CAMPAIGN BULLETIN

Brake Fluid Flush Voluntary Service Campaign

Reference: POA08

Date: June 2, 2021

BRAKE FLUID

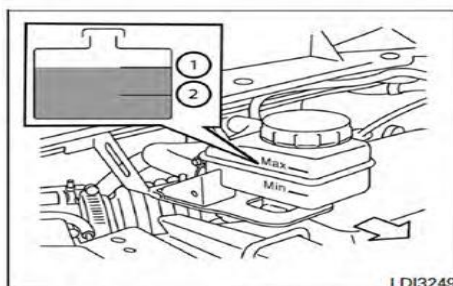
Check the fluid level in the reservoir. If the fluid is below the MIN line (2) or the brake warning light comes on, add Genuine NISSAN brake fluid CLARIANT 6M DOT4 or equivalent DOT4 up to the MAX line (1). If the fluid must be added frequently, the system should be checked by a NISSAN dealer.
